ADDENDUM NO. 06
February 1, 2022

To Drawings and Specifications dated December 17, 2021

CLINE ELEMENTARY SCHOOL CAMPUS REPLACEMENT
FOR FRIENDSWOOD I.S.D.

Prepared by: PBK
11 Greenway Plaza, 22nd Floor
Houston, TX 77046-1104
PBK Project No: 20380

2 AMPHITHEATER STAIR

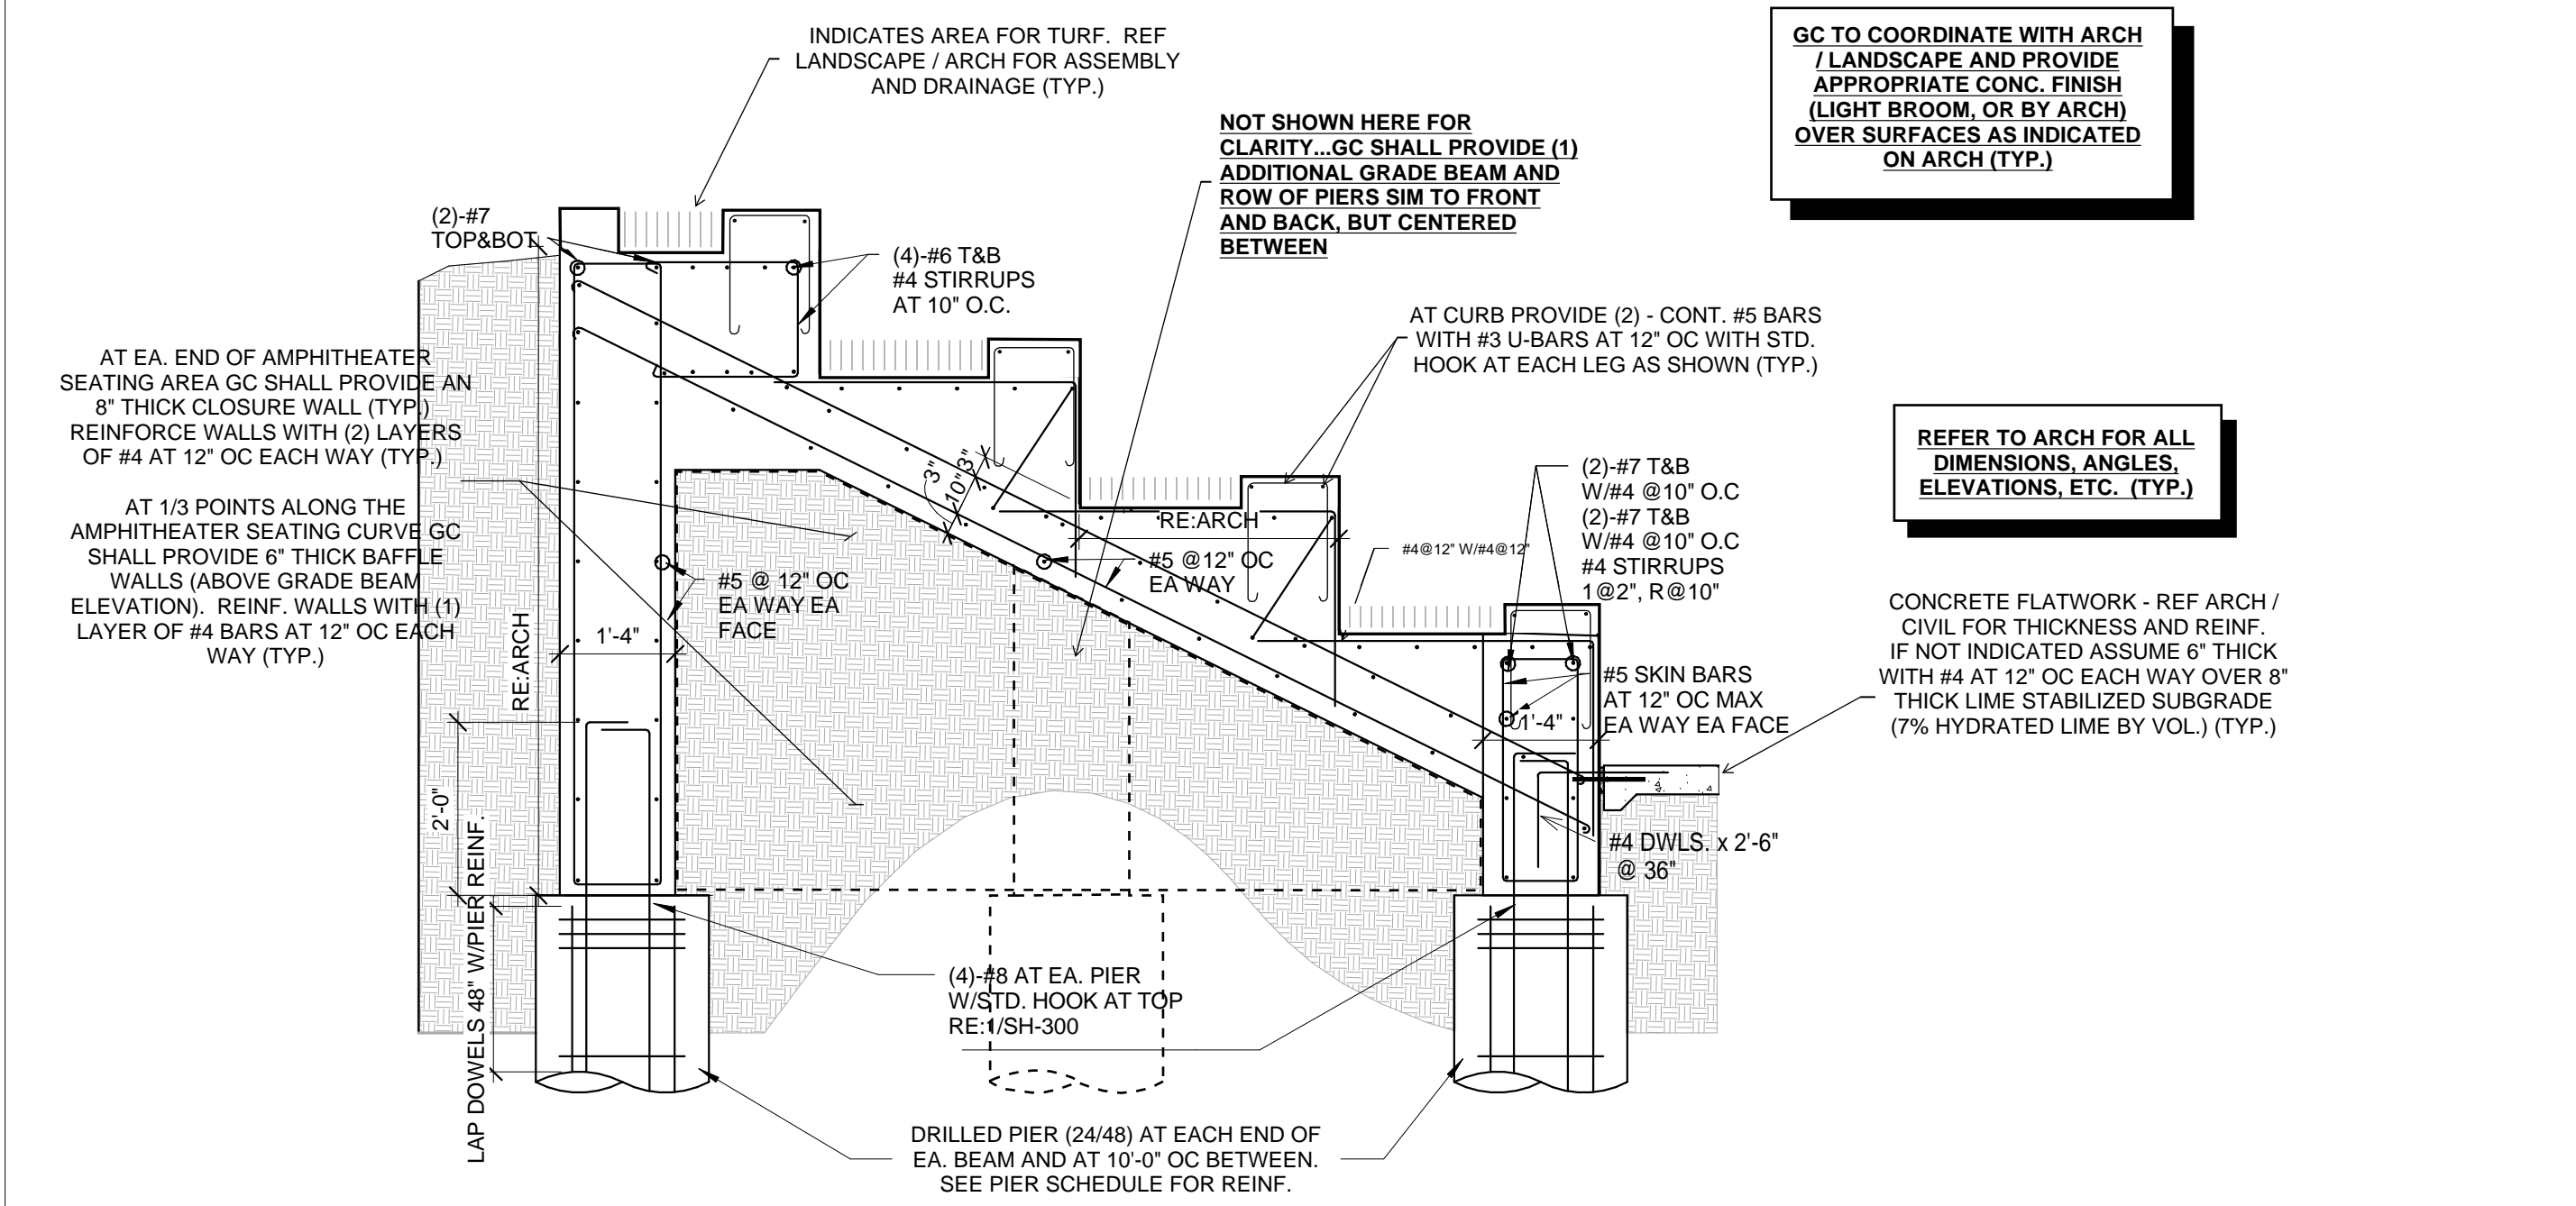
- Item No. 1 Please provide details & section views on S-101H for Amphitheater Seating.
Refer to addendum 06.
- Item No. 2 Please provide plan, details, sections on S-101-H for dumpster enclosure.
Refer to addendum 06.
- Item No. 3 Please provide sections and details for Learning Stairs on S-105.
Refer to addendum 06.

- Item No 06 **S-101H – FOUNDATION AND 1ST LEVEL PLAN – AMPHITHEATER & DUMPSTER**
 - 1. New Amphitheater Section 2/S-101H added to sheet. GC to determine length of beam segments based on the number of piers provided in the foundation plan.

FOUNDATION DETAILS AND SECTIONS

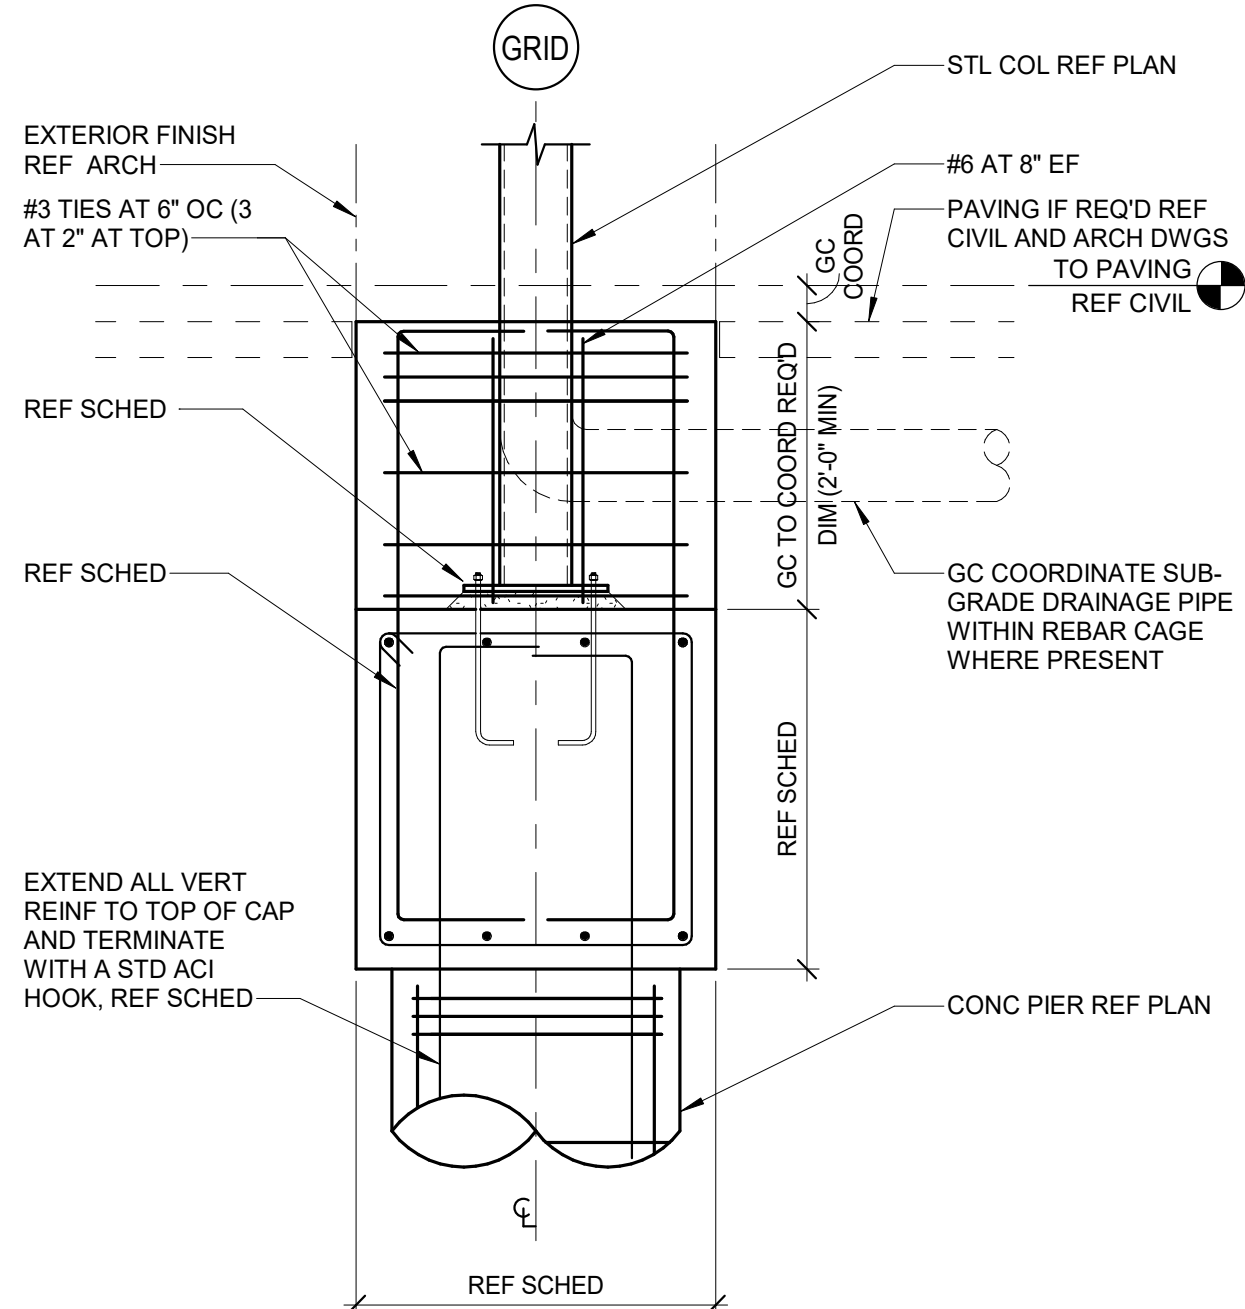
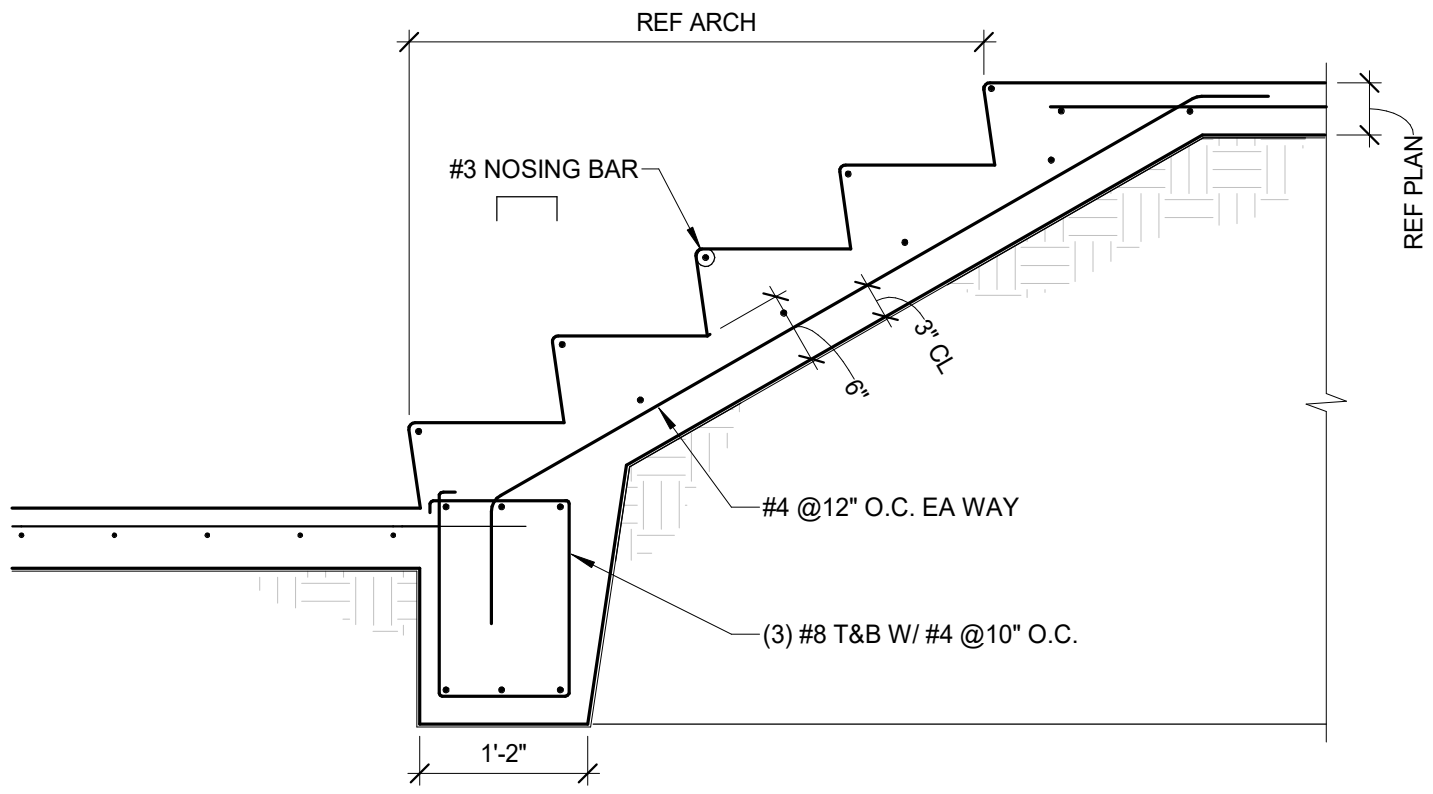
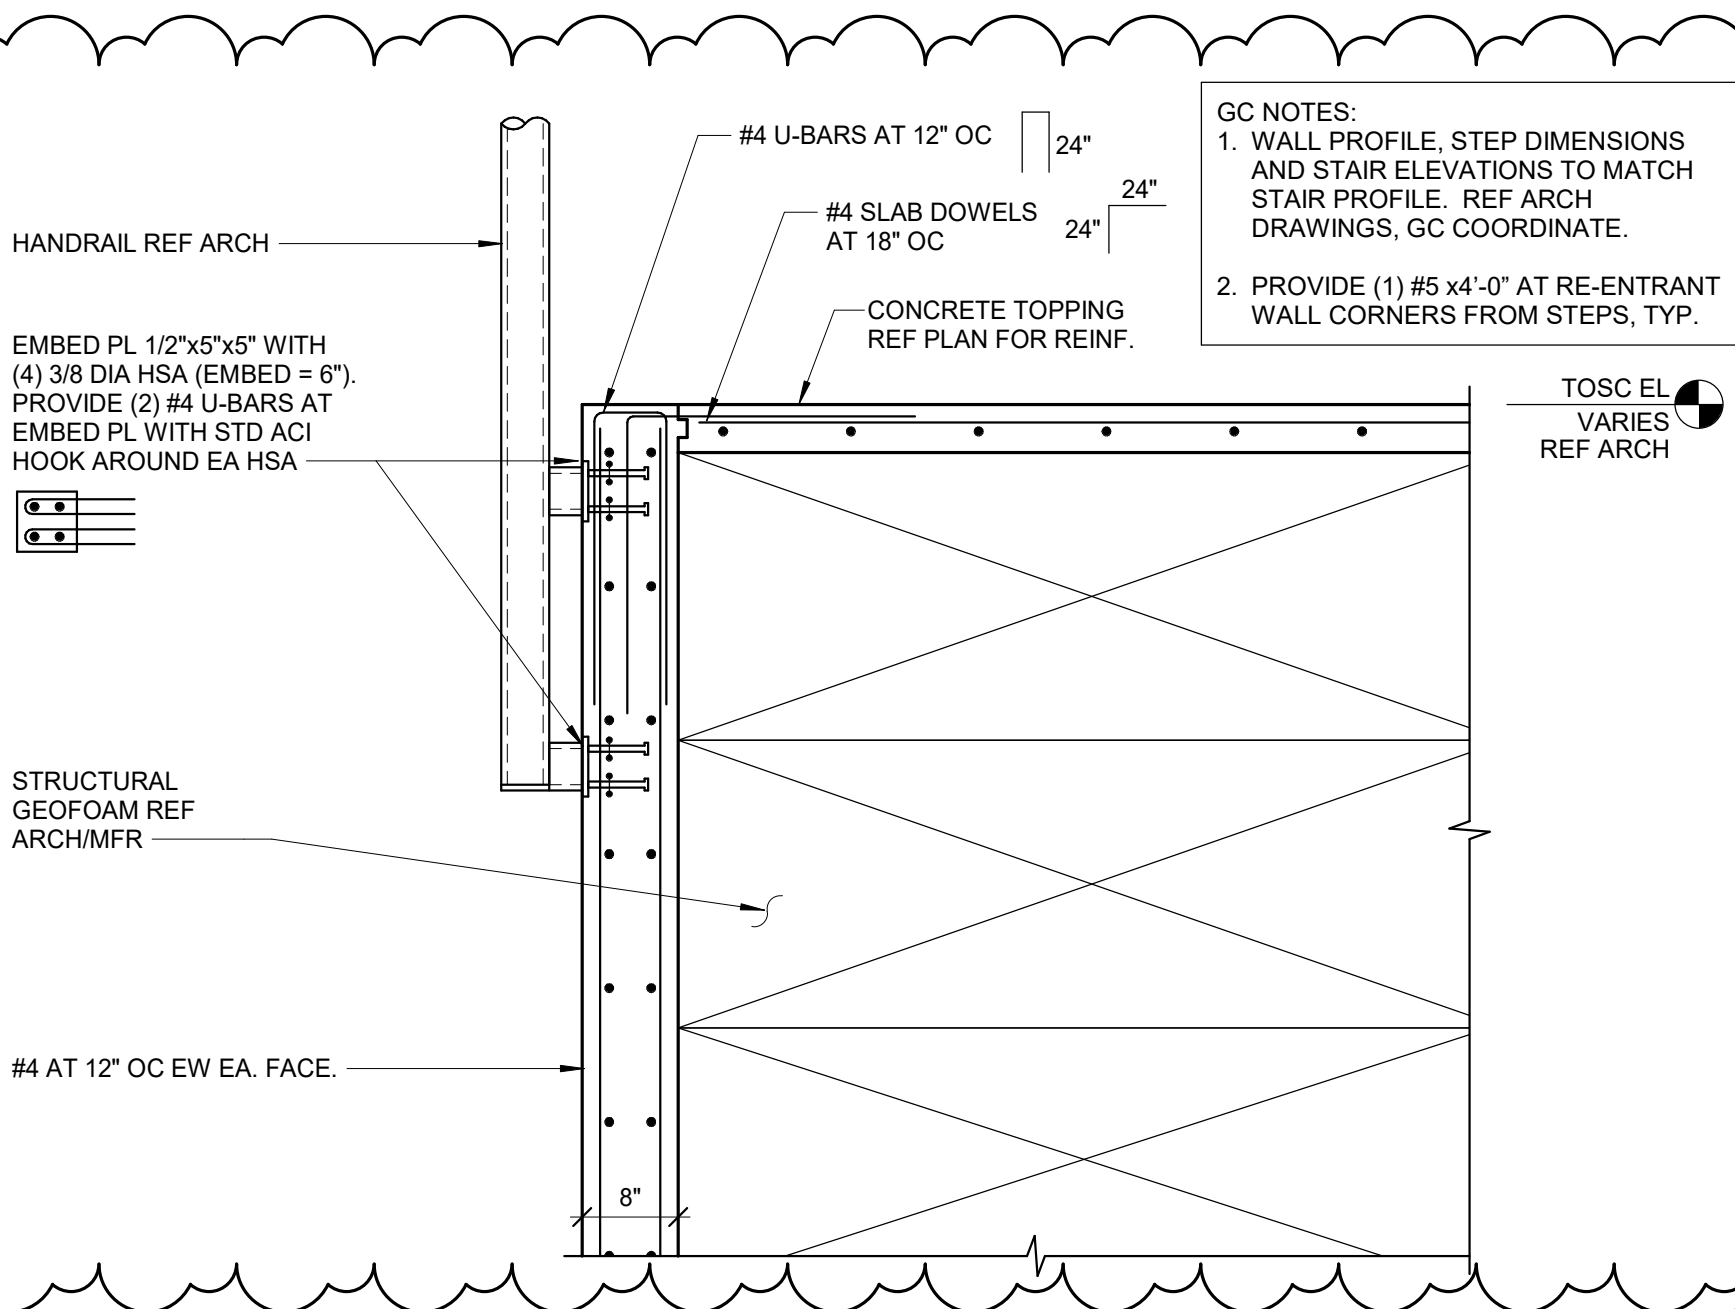
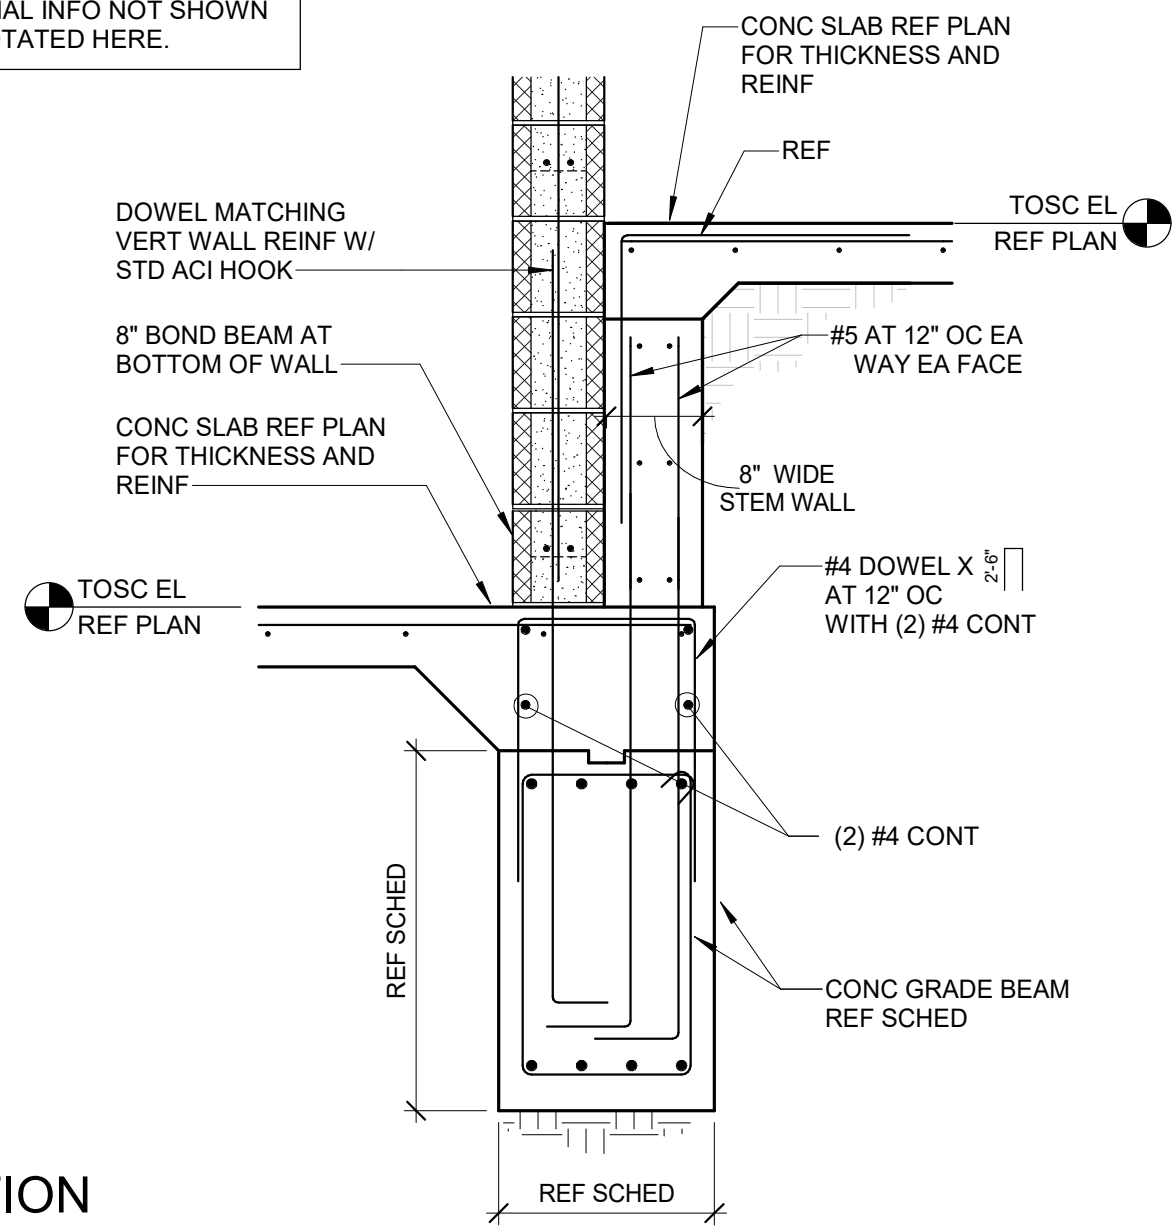
1. 5/S-315 revised. See reissued sheet S-315.
2. 6/S-315 revised. See reissued sheet S-315.
